# METROPOLITAN GOVERNMENT OF NASHVILLE AND DAVIDSON COUNTY

## STAFF RECOMMENDATION 924 McFerrin Avenue December 18, 2019

**Application:** New Construction—Addition  
**District:** Greenwood Neighborhood Conservation Zoning Overlay  
**Council District:** 05  
**Base Zoning:** MUN-A  
**Map and Parcel Number:** 08208010600  
**Applicant:** Wendy Cheney  
**Project Lead:** Melissa Sajid, [melissa.sajid@nashville.gov](mailto:melissa.sajid@nashville.gov)

| <p><b>Description of Project:</b> This application is to construct a rear addition to a contributing building.</p> <p><b>Recommendation Summary:</b> Staff recommends approval of the application with the conditions:</p> <ol style="list-style-type: none"><li>1. All railings shall have a simple design;</li><li>2. Staff approve the final selections of the roof material and color, windows, door, folding wall system, pergola posts, ramp, driveway and parking pad, and fencing prior to purchase and installation; and</li><li>3. The HVAC shall be located behind the house or on either side, beyond the midpoint of the house, and utility meters shall be located on the side of the building, within 5' of the front corner or on the rear or rear-s

ARCHITECTURAL  
PLAN

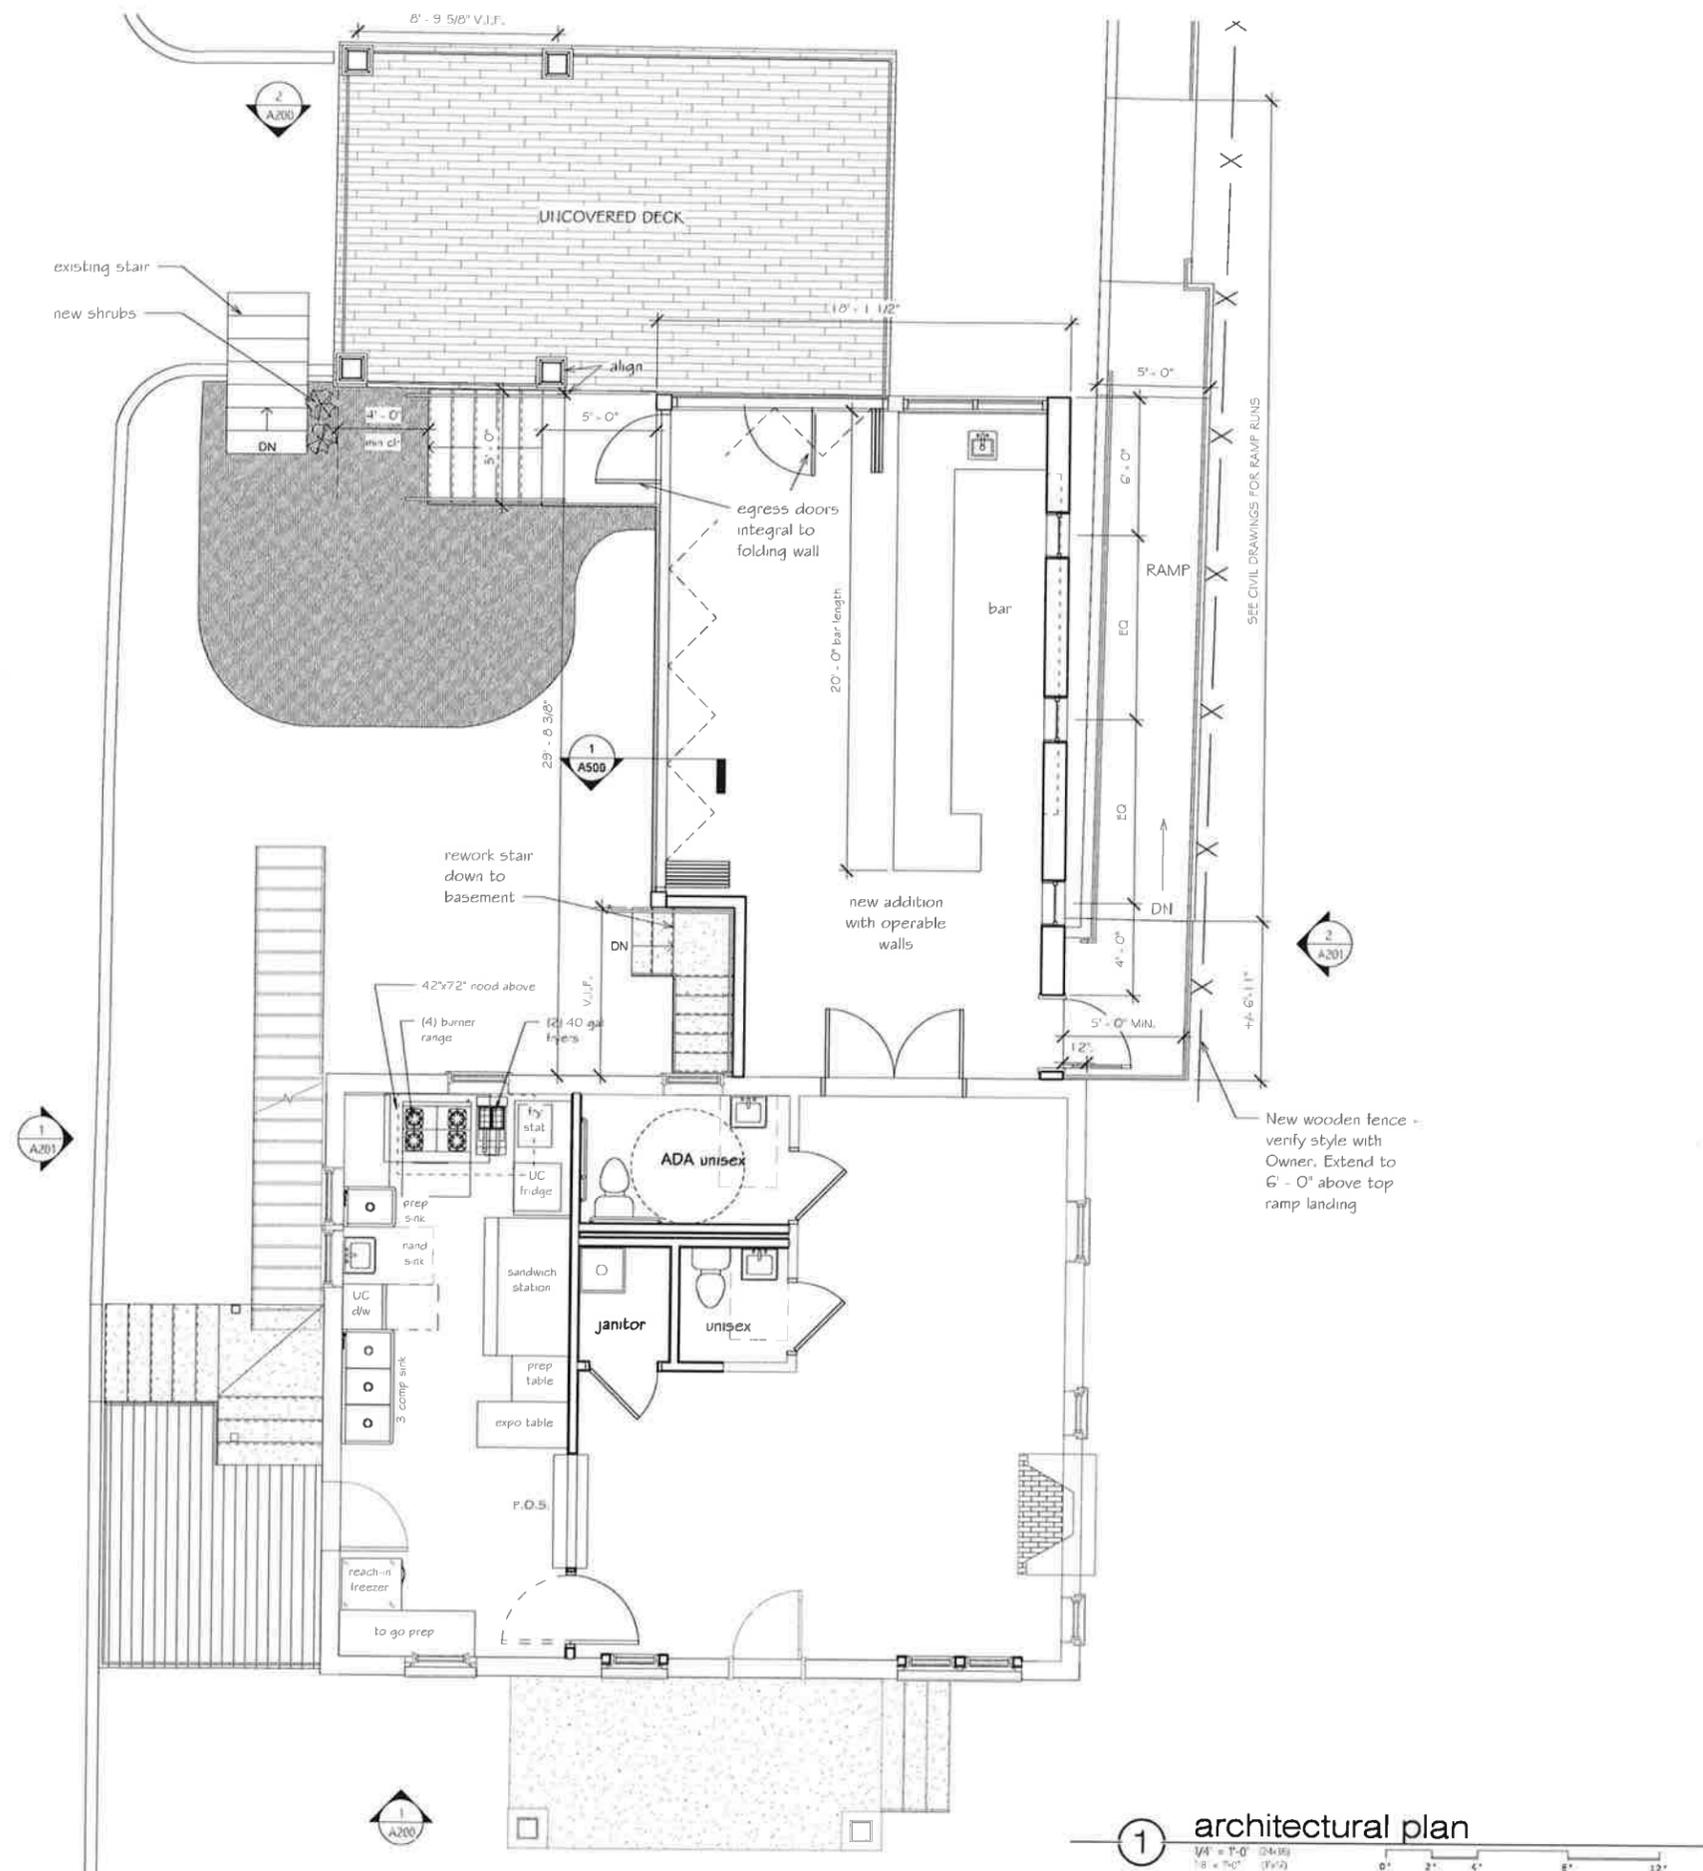
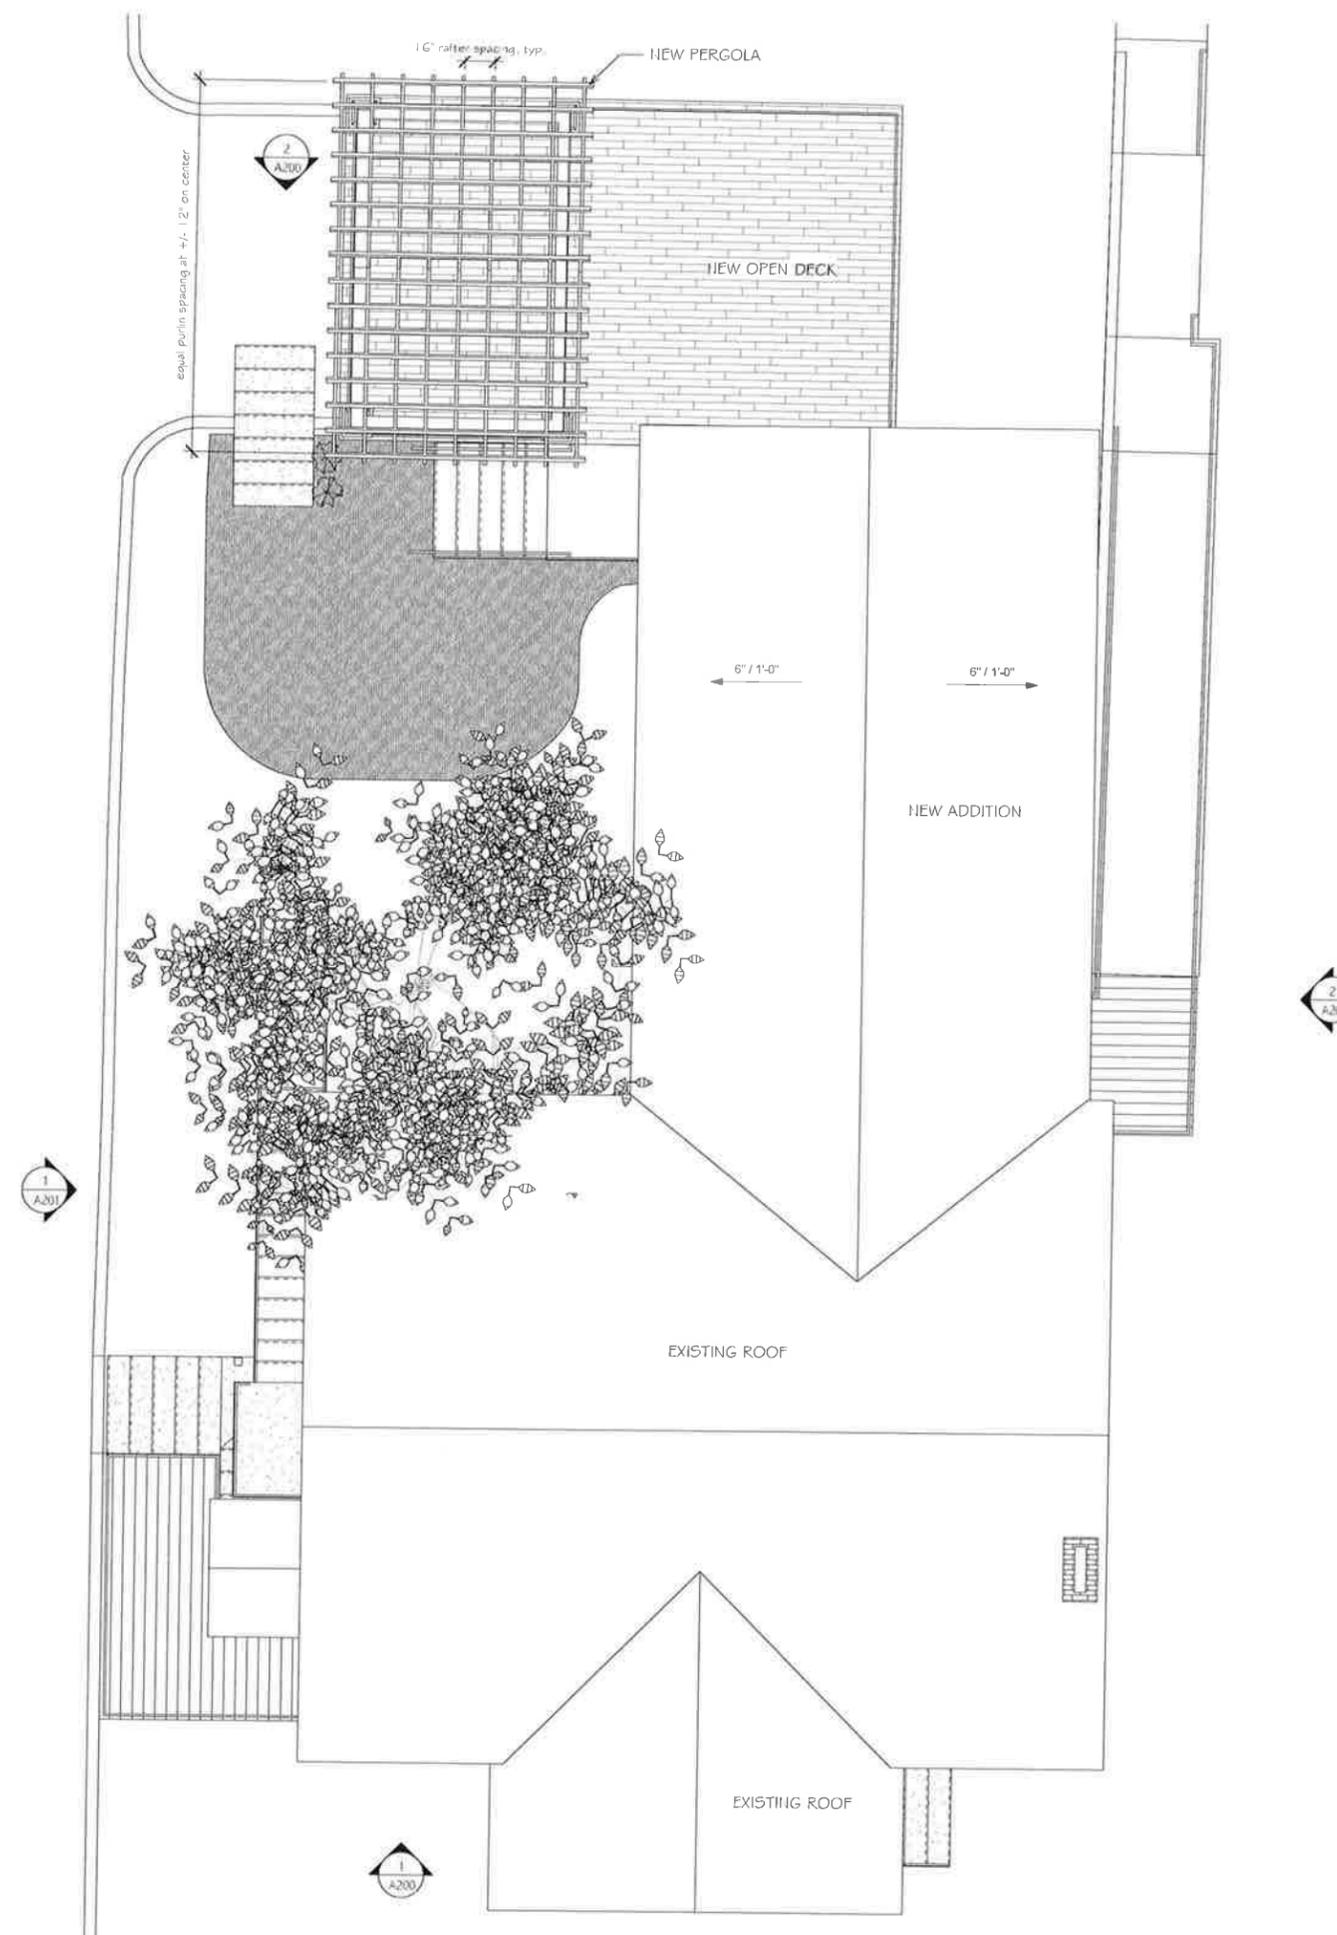
Design, Location & Removability: The plan proposes a rear addition and deck that will be covered with a pergola. As proposed the addition is situated at the rear of the historic building and is inset one foot (1') from the right rear corner and fourteen feet (14') from the left rear corner. An existing detached outbuilding that sits lower than the historic house is to be demolished as previously permitted (HCP 2019025093). The foundation of the new addition will extend to this area, creating a basement level with a foundation line that will match that of the historic building. A pergola will be located above this part of the addition. The pergola will have a side-gabled roof form and will sit two feet (2') below the primary part of the addition and a total of six feet (6') lower than the peak of the historic building.

The left-side and rear walls of the addition incorporate a folding wall system similar to a nanawall. Staff finds that this type of wall system could be appropriate since it has an open appearance is similar to a screened porch.

1 SOUTH SIDE ELEVATION

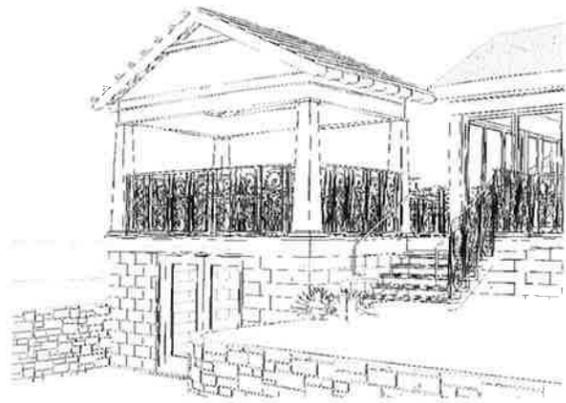
The addition will be primarily clad in stucco to match the existing stucco in the gable fields of the historic house. The railings will be metal. Staff recommends that the railings, including the replacement railings for the exterior stair, be of a more simple design rather than the ornamental design proposed, which is not typical for a bungalow and could create a false sense of history.
